25-2269 (3109)

TITLE PAGE

HEATHWOOD HOMES - 217132
WALLACETON, KITCHENER, ON

GROUND FLOOR PLAN, ELEV. 'A'

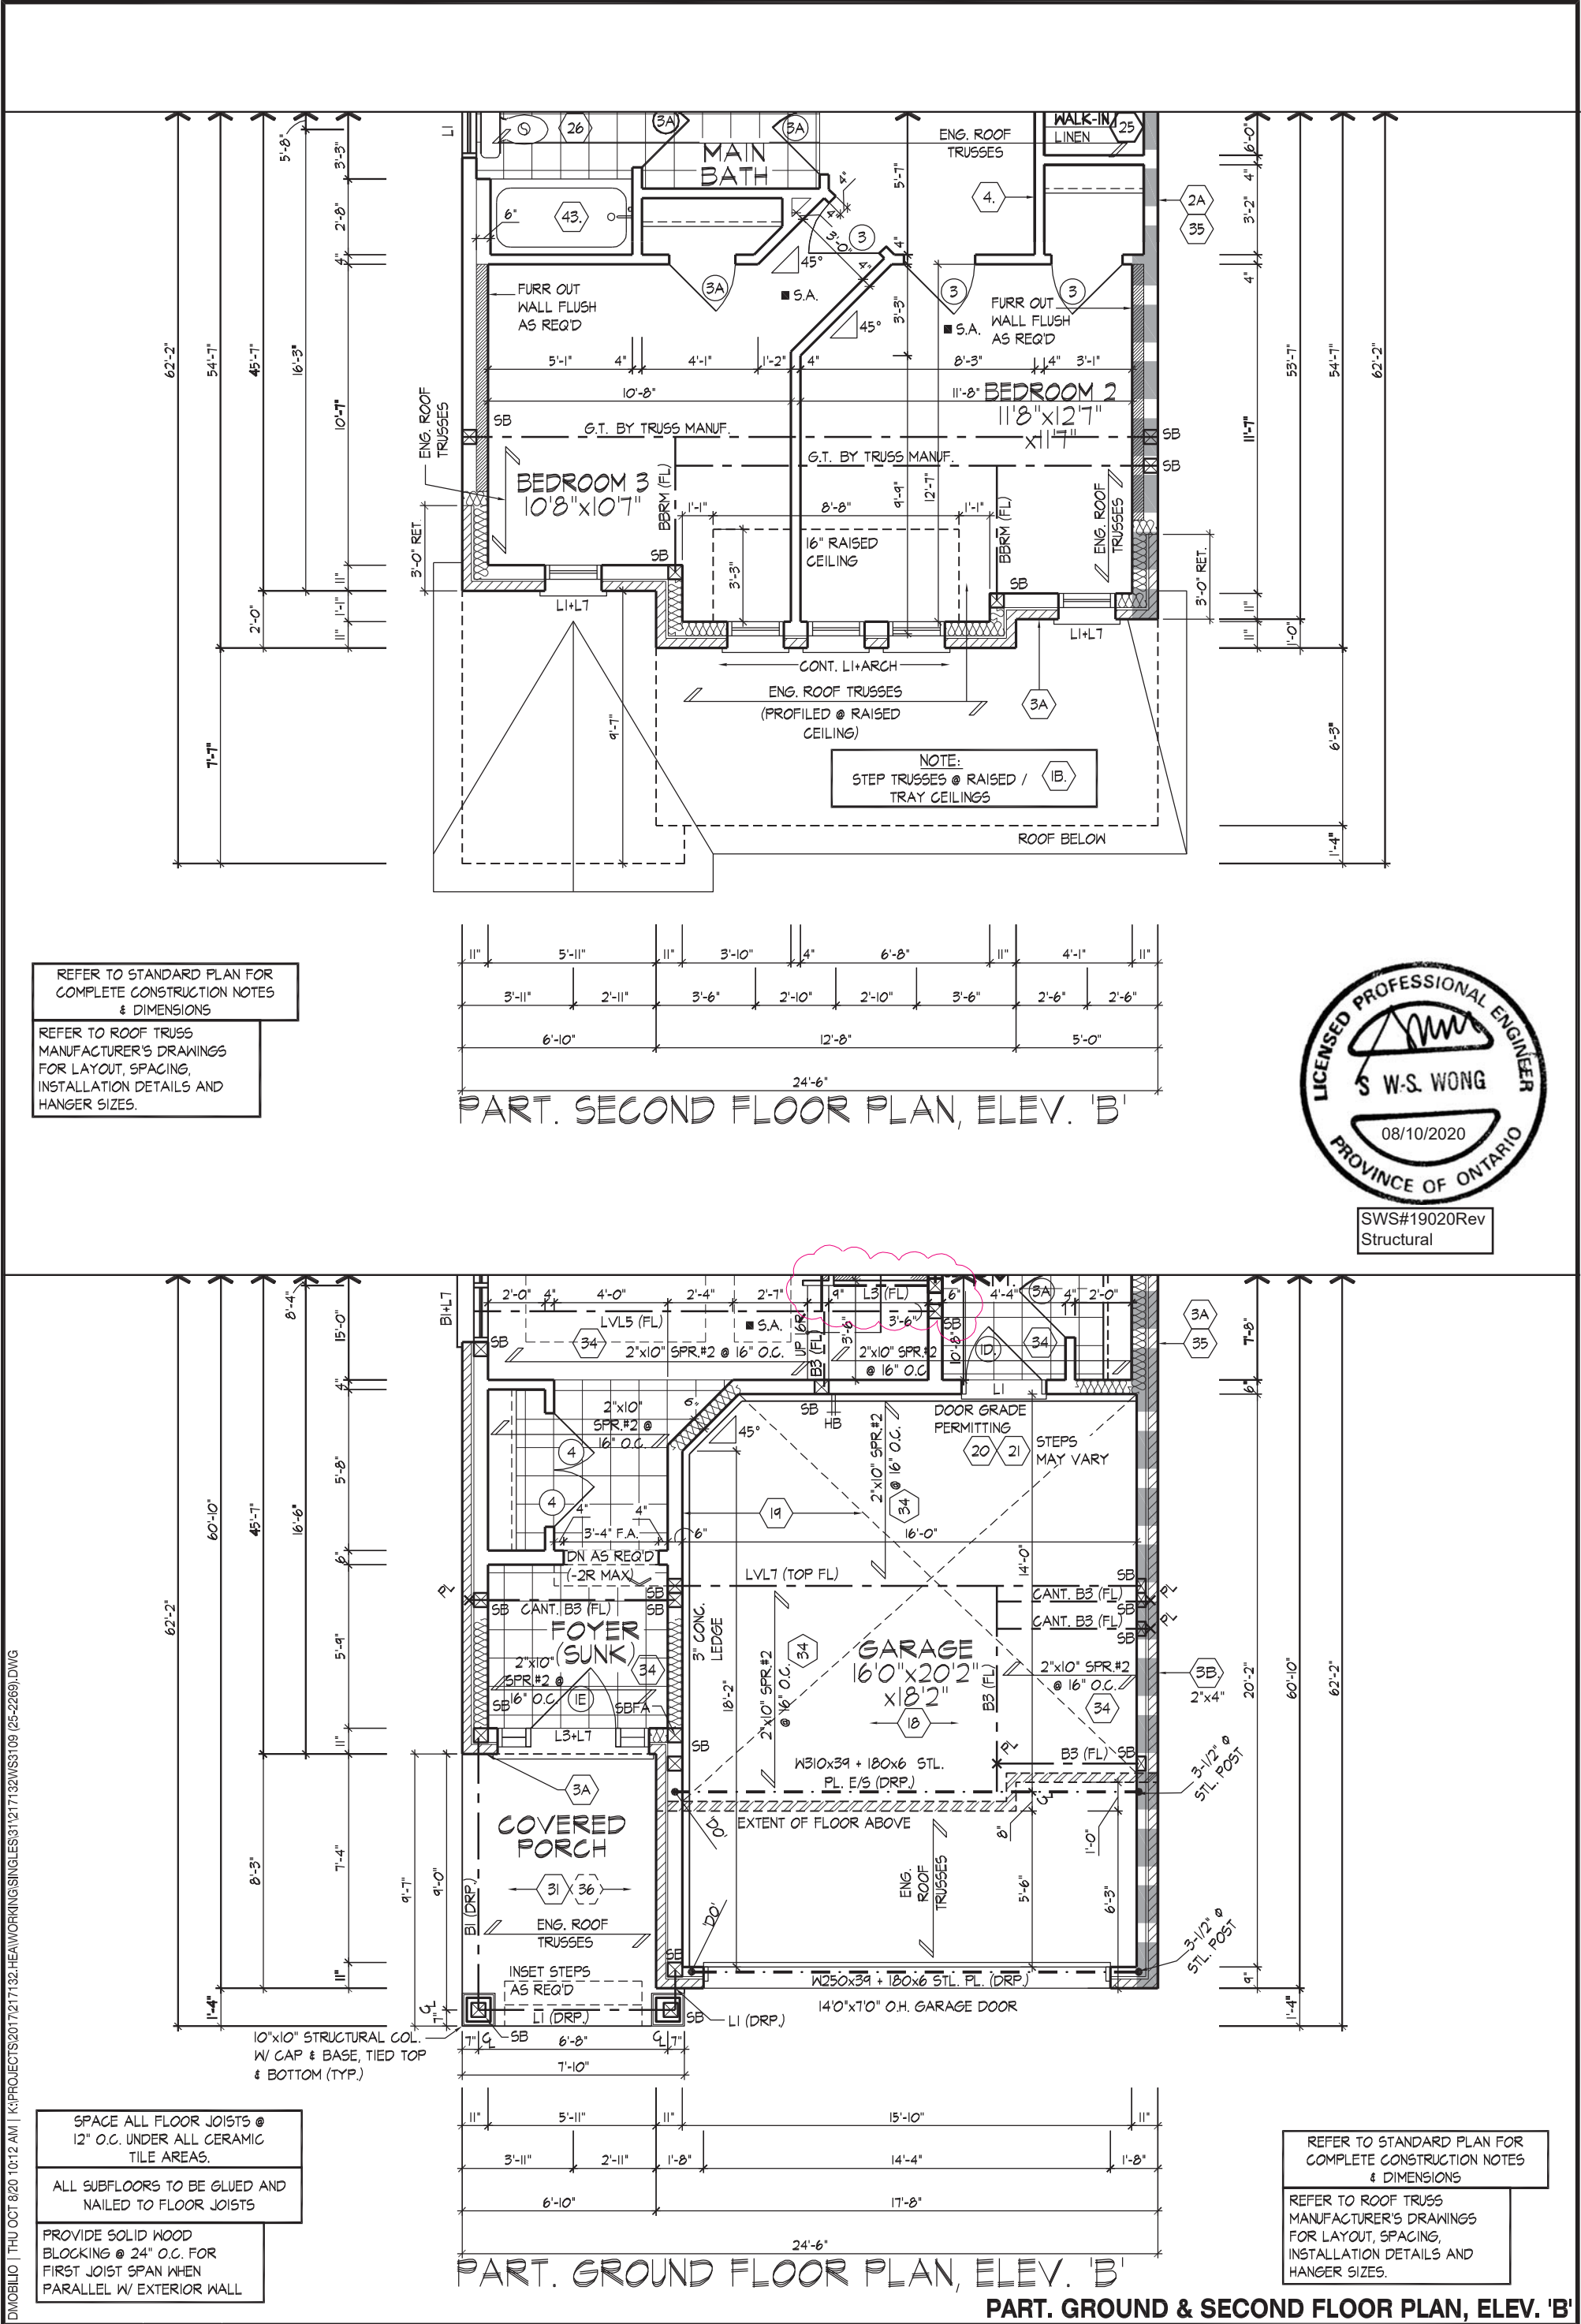
Drywall finished opening

For this arch only:
Move it as much as possible towards the great room with 32" opening, and drop it accordingly to clear the trim above.
